# Fact Sheet for NPDES Permit WA0045586

## Lehigh Cement Company

## **Appendix E - Response to Entity Comments**

### Draft Permit WA0045586 and Fact Sheet

**Figure 1: Facility Location Map**

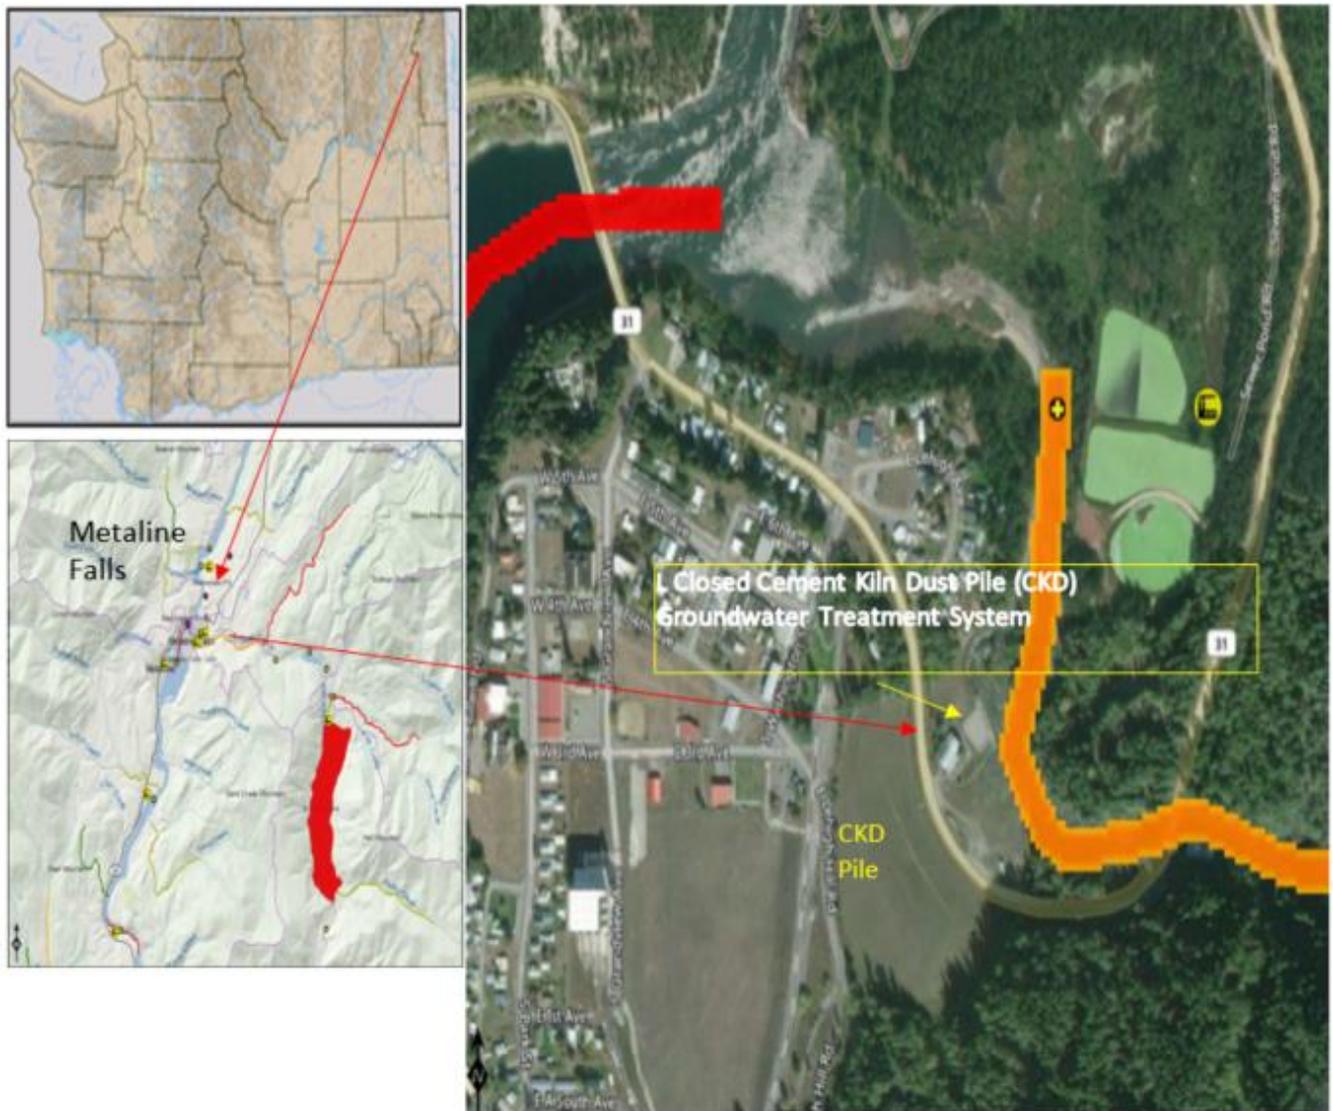
8. Page 7 of 64 Figure 1: Image of site on left side of figure has text: "Lehigh Cement Closed Kiln Dust Pile (KDP)." This should be "...Closed Cement Kiln Dust Pile (CKD)". As defined on first page of Fact Sheet.

**Ecology Response:** Thank you, the acronym is consistent.

**Figure 4: Carbon Dioxide Treatment Schematic**

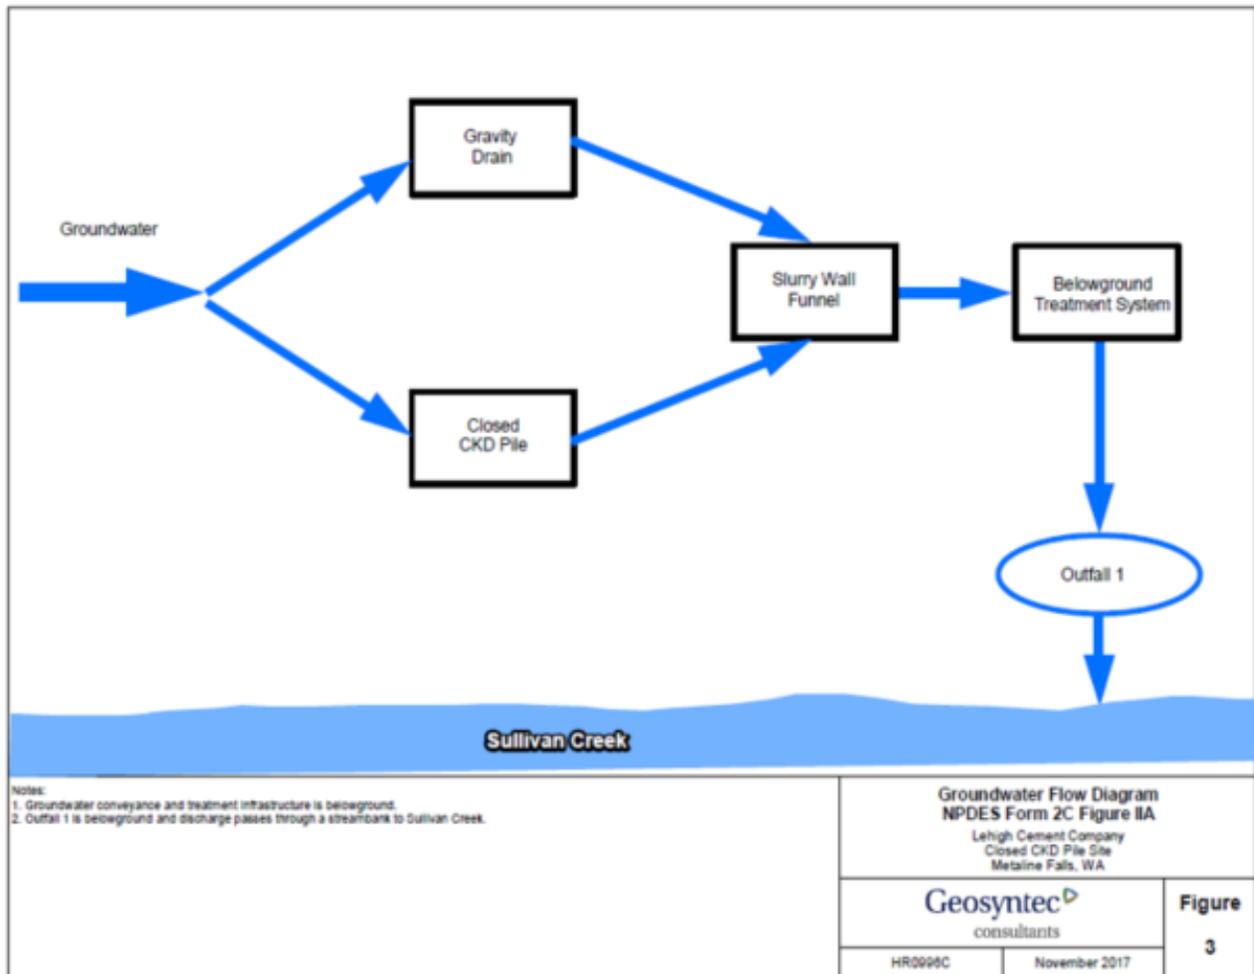
38. Page 13 of 64, first paragraph, first sentence: The draft Fact Sheet states that the system flows "...into Sullivan Creek through three outfalls to the streambank stabilization structure into the creek via gravity (Figure 4)." The system does not discharge to the creek through three outfalls. The system discharges to Sullivan Creek through a diffuser that represents a single Outfall. There are three outlets connected to the streambank diffuser that then discharges via subsurface flow to the creek.  
As the existing permit issued in 2006 makes clear, the system represents a single outfall (see revised Figure 4, and Attachment A).

groundwater levels are below the gravity drain outlet. We have provided an updated Figure 4 that illustrates that the three outlets convey treated water to the streambank through a diffuser.

Ecology will replace line and box diagram with the updated flow diagram provided. However, there does appear to be a second outfall, which discharges stormwater and snow melt from the closed kiln dust pile (CKD). Ecology added a Figure 4 below to the fact sheet showing the location of the CKD stormwater drainage.

**Ecology Response:** Ecology updated as discussed in comment 2.

**Figure 2: Updated Line and Box Flow Diagram Provided by Lehigh**

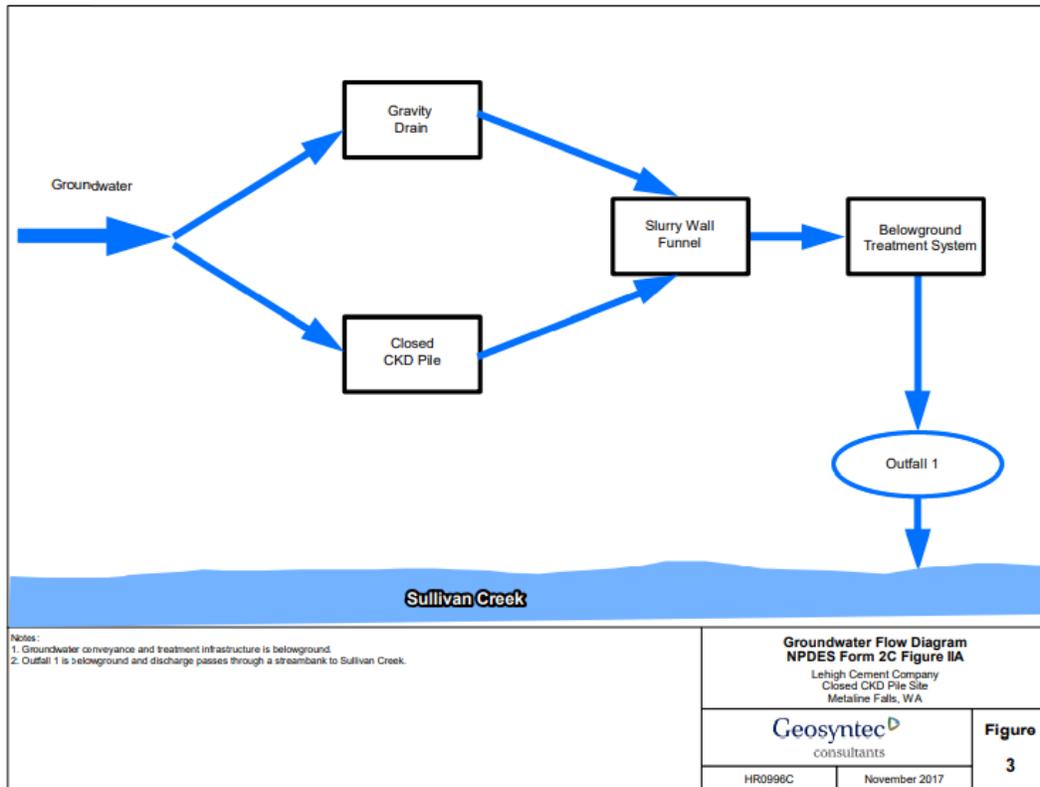
**Commented [DP2]:** There is no second outfall. This captured precipitation is entirely transported to the treatment system and discharges through Outfall #1. See updated Figure 3, submitted with the permit renewal package.

13. Page 12 of 64, Figure 3: This figure is from 2006, and does not represent the site as it currently is configured. An updated flow diagram was provided in the NPDES Permit Application, and is attached as Figure 3 for use here. The key item is that there is no "Outfall 2". All flow from the gravity drain is routed to the treatment system.

**Ecology Response:** Figure 3 updated.

Provided below suggested track changes to the description of the Discharge Outfall on page 13 of 64.

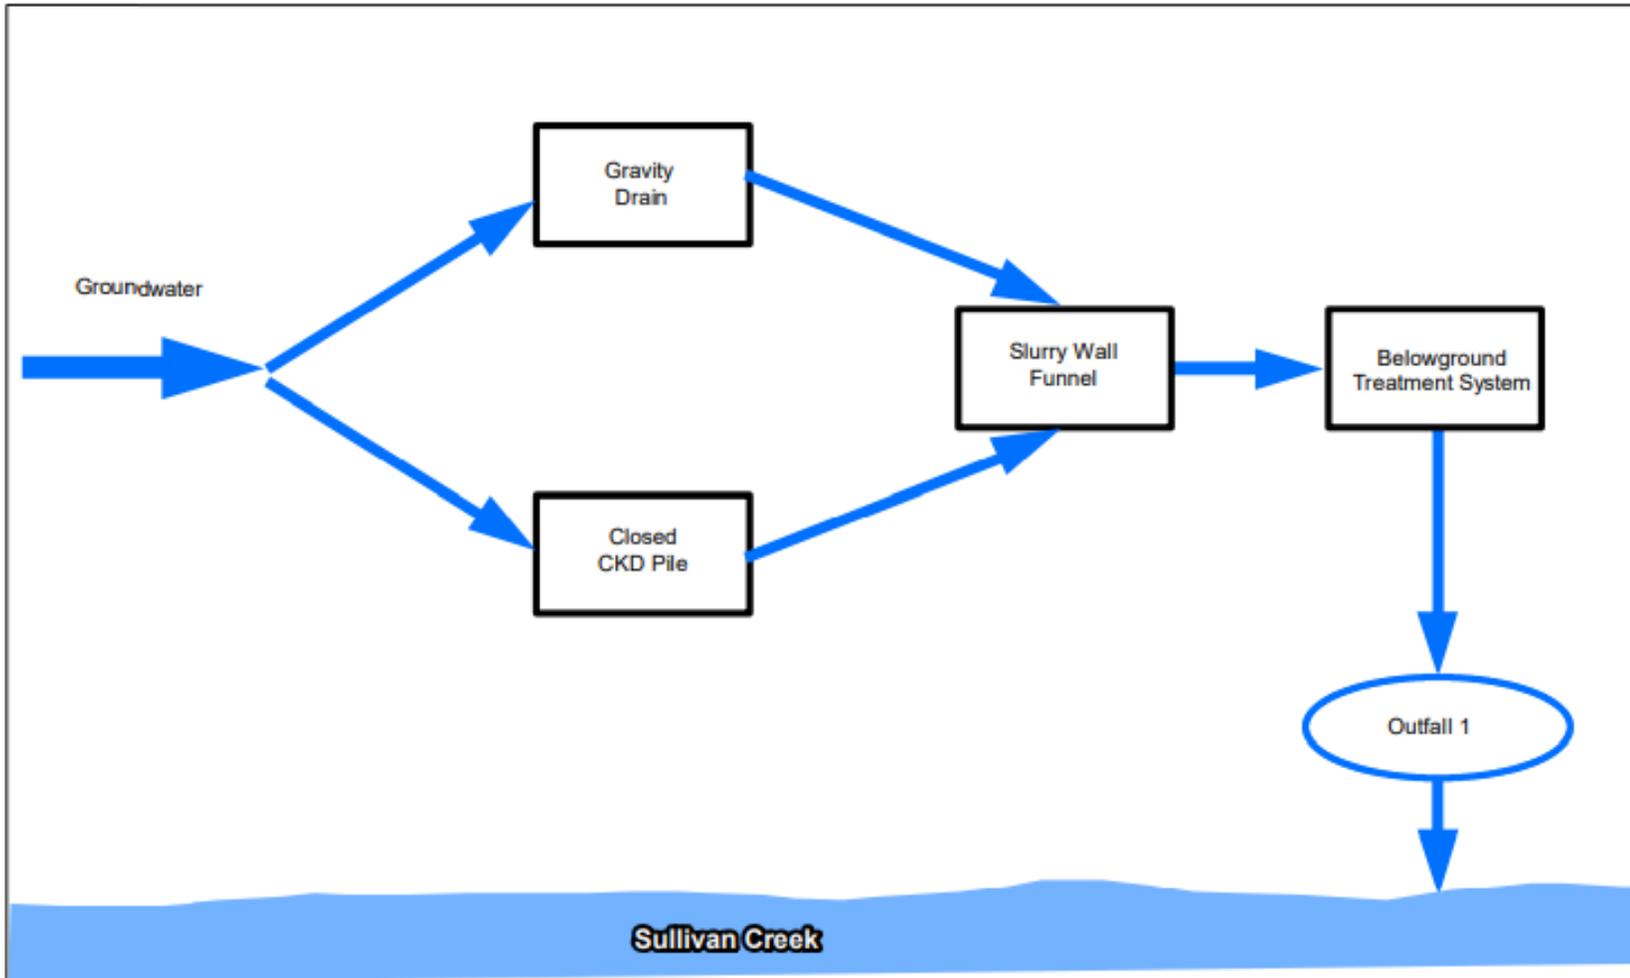
The treated effluent flows through the subsurface intermittently ~~into toward~~ Sullivan Creek through a diffuser (i.e., gabion baskets) within three outfalls to the streambank stabilization structure then into the creek via gravity (Figure 4). The mixing study submitted with the permit application assumed that the ~~sheet flow diffuser~~ of effluent ~~through the bank into the creek~~ imparts no horizontal momentum to the creek.

**Commented [DP2]:** There is no second outfall. This captured precipitation is entirely transported to the treatment system and discharges through Outfall #1. See updated Figure 3, submitted with the permit renewal package.

**Ecology Response:** Ecology agrees that the treatment system discharges to a diffuser that serves as the outfall to Sullivan Creek. However, the diffuser has no single point of compliance. The three valves that open pipes that discharge to the diffuser therefore serve as the points of compliance.
